64925301
B125315
REV. C

Item Name: Lower Deflector Assembly

ENGINEERING CHANGE NOTICE NO. 04057

DWG TITLE: DEFLECTORS

A/R	5	601.2045	RTV, LOCTITE 598		△
2	4	601.3074	RIVET	MS20470AD6-12	
1	3	649.5312	BREAKAWAY TIP		△△
	2	649.5311	UPPER DEFLECTOR		△△
1	1	649.5310	LOWER DEFLECTOR		△△
		649.5301	LOWER DEFLECTOR ASSY		
	FIND #	PART #	DESCRIPTION	MAT'L	SPEC.

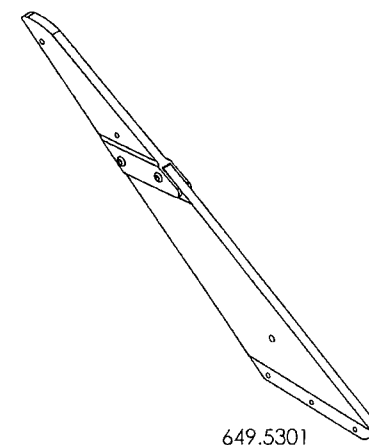
Root Cause		Date	Step	Qty	Description of work order update or non-conformance	Initial Chief Eng	Action Description	Sign & Date	Verification	QC Inspector
Design		14.10.29	120	12	MS20470 AD6-12 RIVETS ARE TOO SHORT. SUCKED HEAD TO SHORT	A.P. 14.10.29	DRILL OUT RIVET & REPLACE WITH NEXT SIZE UP *See attached email	DAS 41 9-89 14-11-2		
Doc/Data										
Equip/Tooling										
Handling/Pre										
Material										
Operator										
Offset/Setup										
Process										
Supplier										
Training										
Transport										
Unapproved

Sorry,
I meant to change to a -14 length ,not -13.
JL

Hi Pablo,
Rivets seem to be to short,could we change length from MS20470AD6-12 to MS20470AD6-13.
If this is acceptable I will submit an ecr.
THX
JL

This should be fine.
